# Notes for Users

This supplement provides notes and corrections for the manuals provided with this machine. Read this supplement in conjunction with the relevant manual.

D088-7608

#### Access to the machine

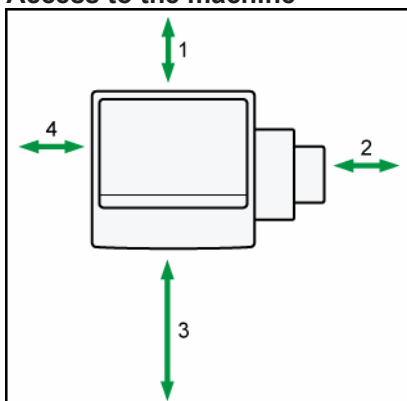
"Machine Environment" in 7. Remarks in *Operating Instructions About This Machine*

1. Rear: 10 cm (4 inches) or more

2. Right: 10 cm (4 inches) or more

3. Front: 75 cm (29.5 inches) or more

4. Left: 10 cm (4 inches) or more

## Missing Image Area

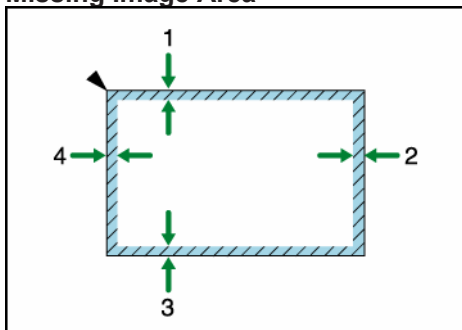
"Missing Image Area" in 1. Placing Originals in *Operating Instructions Copy and Document Server Reference*

BZH047

1. 0.5 - 4.0 mm (0.02 - 0.15 inch)

2. **0.5 - 6.0 mm (0.02 - 0.24 inch) (3.0 - 6.0 mm (0.12 - 0.24 inches) in Duplex mode)**

3. 0.5 - 4.0 mm (0.02 - 0.15 inch)

4.  $4.2 \pm 1.5$  mm ( $0.17 \pm 0.06$  inch)
